SL0021 SMARTlift Top Arm Angle Sensor Cable Service

Date: 18 Oct 07	Author: Richard Brown	SMARTlift	Version 1
-----------------	-----------------------	-----------	-----------

Cable shown with 12mm Spiralflex added.

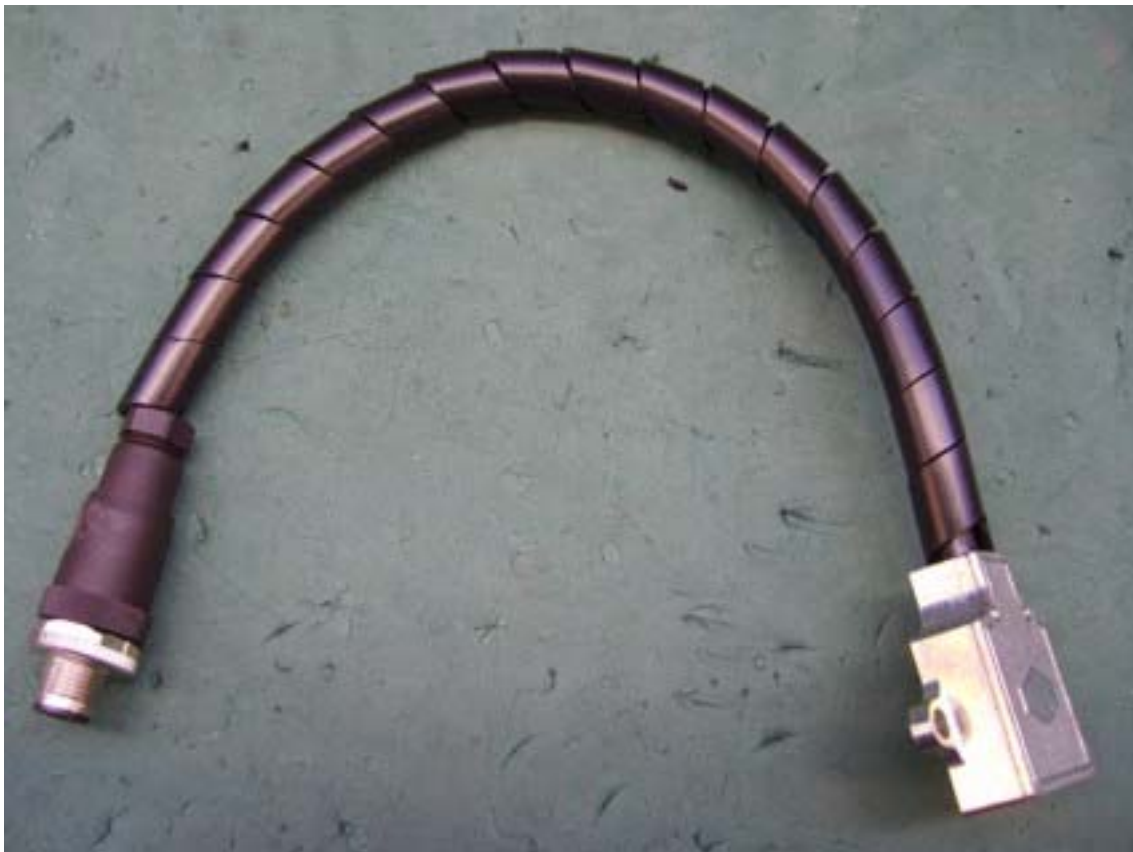
At next service please add 12mm Spiralflex to the Top Arm Angle Sensor Cable to prevent the cable from becoming trapped and crushed between the Top Arm Cylinder Rod Eye and the inside of the Top Arm Fabrication.

The symptom of a possible crushed angle sensor cable will be a blown Angle Sensor Ground 2A fuse in the module junction box. This may cause other Angle Sensors Errors to be displayed too.
